Editor Decision

Editor Decision: Reconsider after major revisions (further review by editor and referees)
by Nunzio Romano

Reply (in blue) to « RC1: 'Comment on hess-2023-152', Anonymous Referee #1, 24 Jul 2023 (<https://doi.org/10.5194/hess-2023-152-RC1>) » (in italic)

Reply (in blue) to « RC2: 'Comment on hess-2023-152', Anonymous Referee #2, 18 Sep 2023 (<https://doi.org/10.5194/hess-2023-152-RC2>) » (in italic)

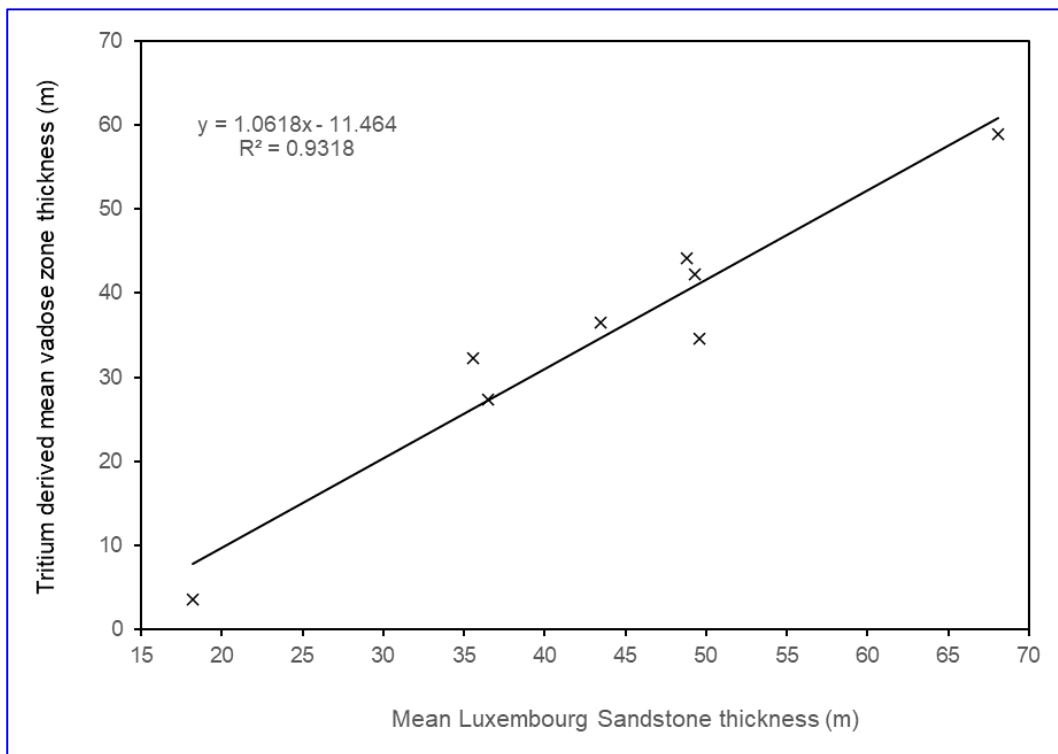
L522: Is this assumption of vadose zone that is the entire thickness of the aquifer reasonable? I think that much more information about the vadose is needed. For instance, are there any wells that can constrain the vadose zone thickness?

We think that this comment/question relates to a misinterpretation of our statement. We do not assume here that the thickness of the vadose zone is equal to the full Luxembourg Sandstone thickness, but we state that the Luxembourg Sandstone thickness can be considered as a "proxy" of the thickness of the vadose zone (which is different). In statistics, a proxy is a variable that is not in itself directly relevant, but that serves in place of an unobservable or immeasurable variable. For a variable to be a good proxy, it must have a close correlation (either positive or negative, and not necessarily linear) with the variable of interest. The validity of our hypothesis can be supported to some extent with the graph shown hereafter which compares our estimates of the mean Luxembourg Sandstone thickness for each recharge areas from Table 1 (x-axis of the graph hereafter) to the mean vadose zone thicknesses that can be derived from the tritium results (subtracting H_{exp} values indicated in Fig. 8 from the mean Luxembourg Sandstone thickness values in Table 1; y-axis of the graph hereafter).

However, we agree with Referee #1 that it would have been preferable to rely on robust direct information to assess the vadose zone thickness for each recharge area. Unfortunately, as mentioned in lines 148-149, hydrogeological drillings in the Luxembourg Sandstone are too sparse and poorly distributed (one can also see the "Hydrogeological drillings" layer in the Luxembourg platform for governmental geodata and service <https://map.geoportail.lu/>). For instance, only one borehole is available in the KR D recharge area and none in the KR G, M, P and D ones (excluding shallow exploratory boreholes drilled in the very near vicinity of spring catchment facilities). However, it is worth noting that Farlin et al (2013a) indicate that the saturated and vadose zones are about 10 m and 45 m thick, respectively, at the level of the observation borehole in the KR D sector, which is consistent with the average numbers we assessed in our study (see Fig. 8).
